SCHEDULE OF <u>AMENDMENTS</u>

S4.55 APPLICATION

Section A & B:

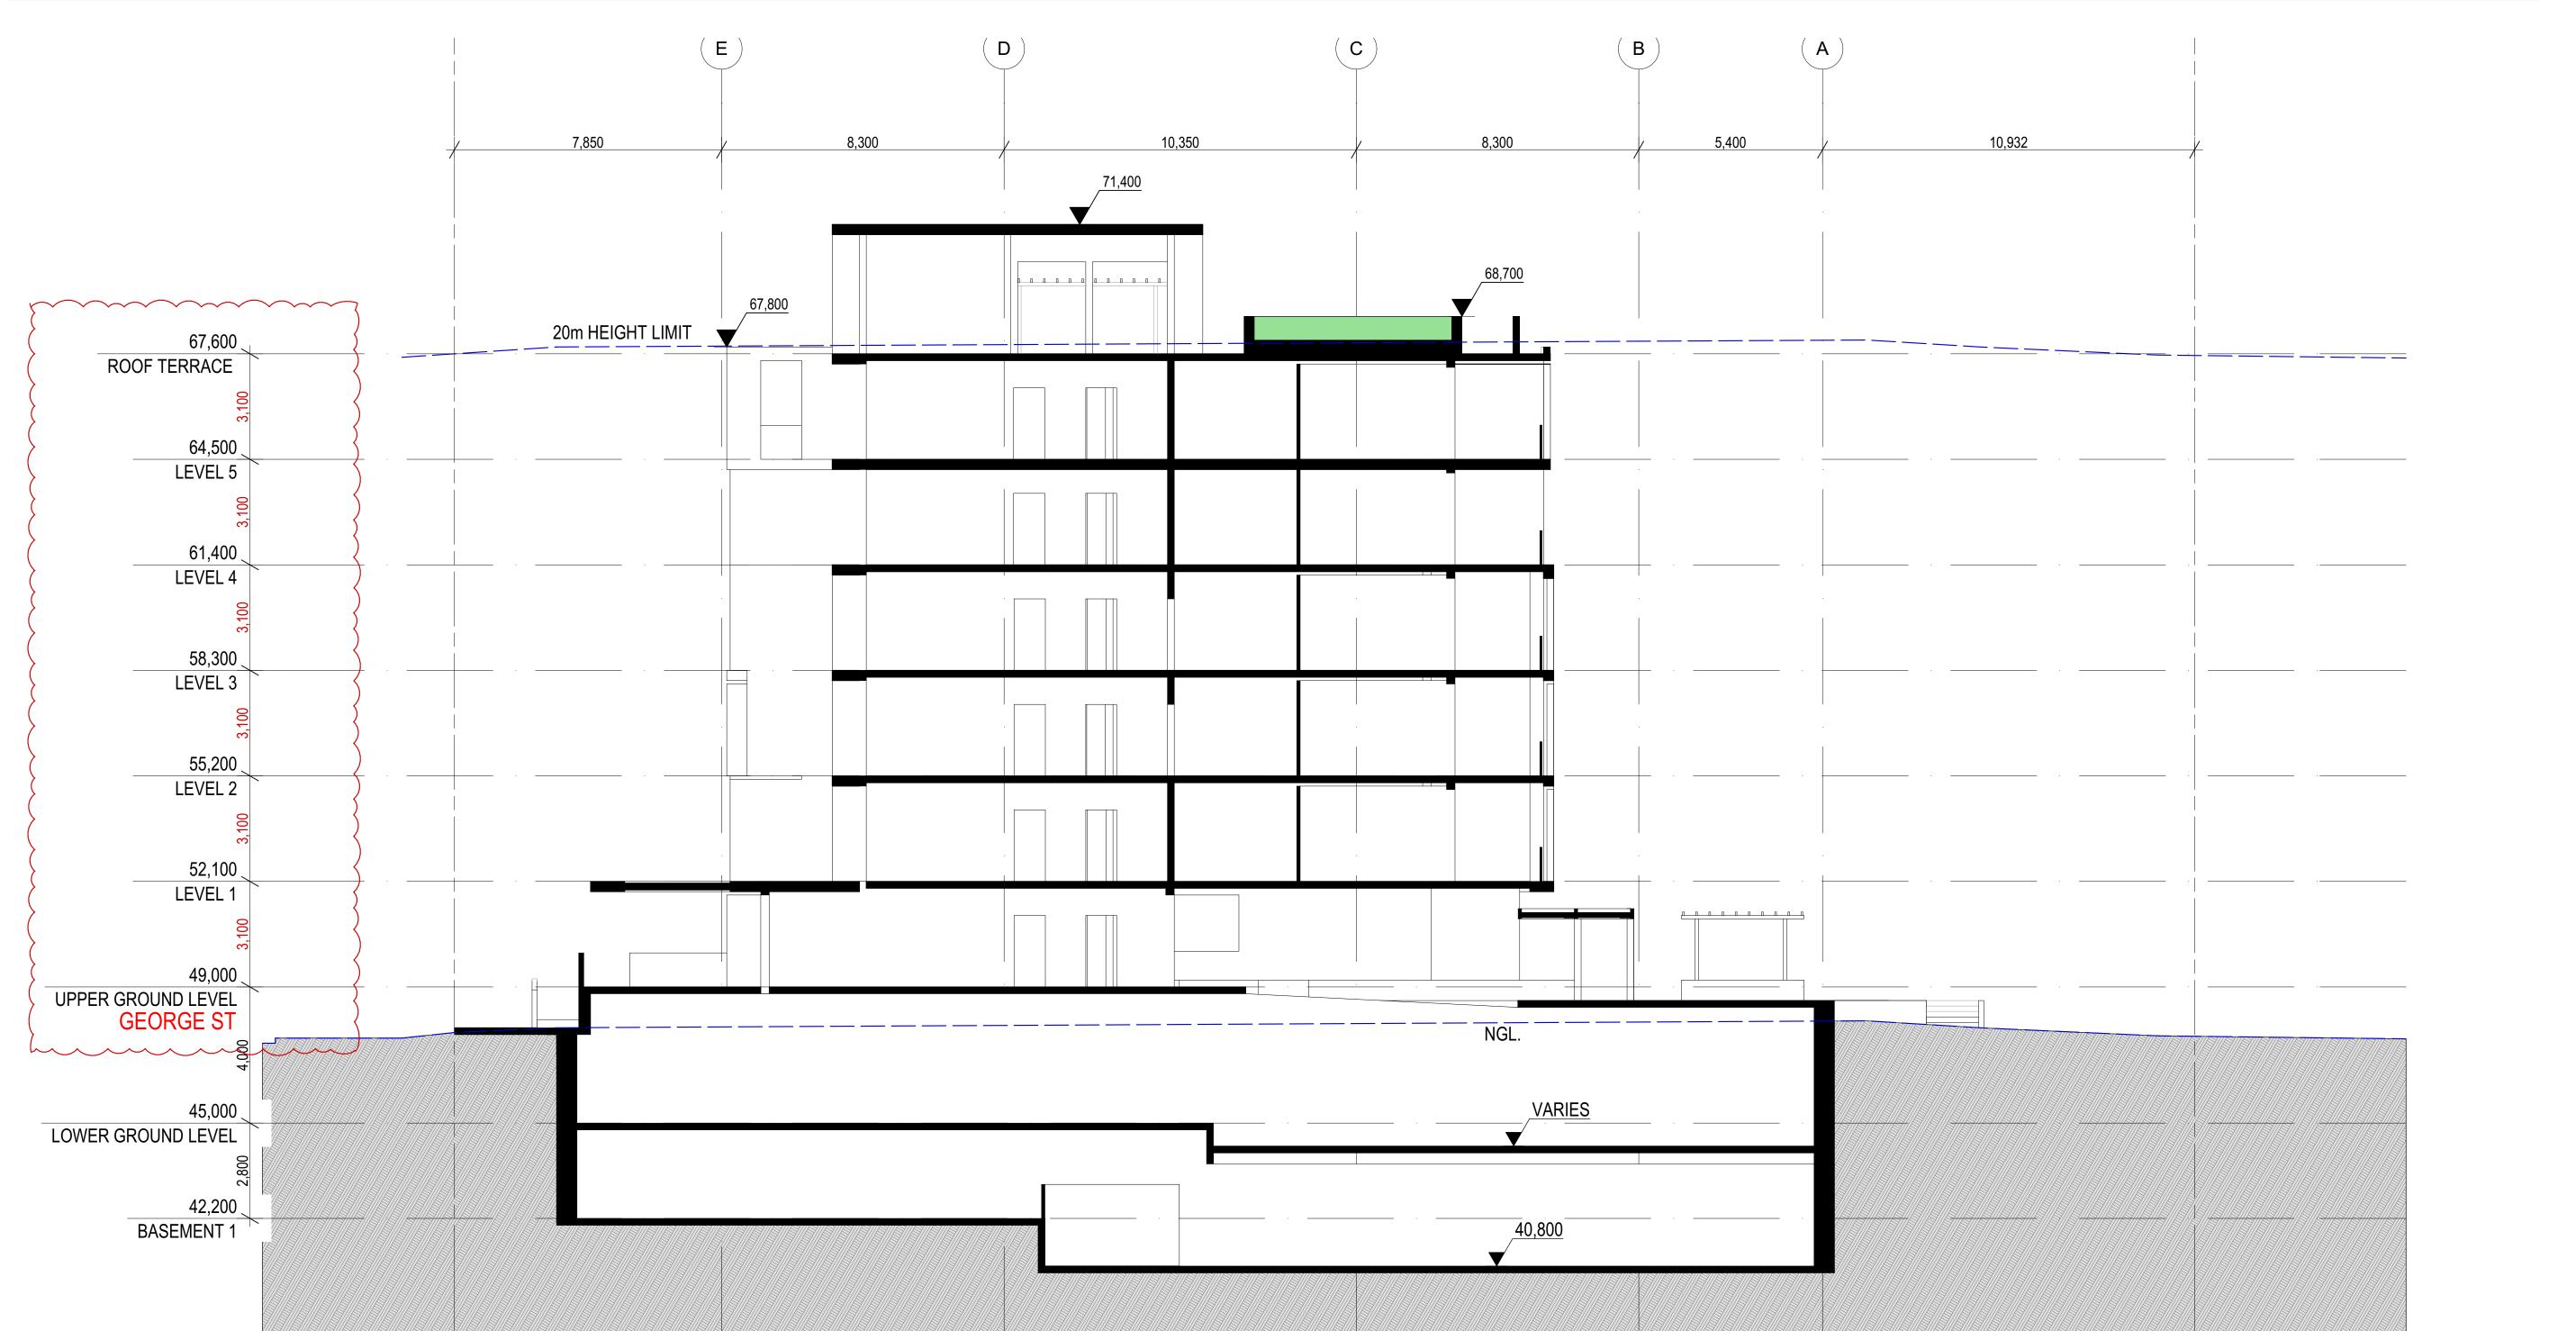
- 100mm increase in height on the residential levels from 3m (floor to

floor) to 3.1m (floor to floor)
- overall height increase to the building by 600mm.
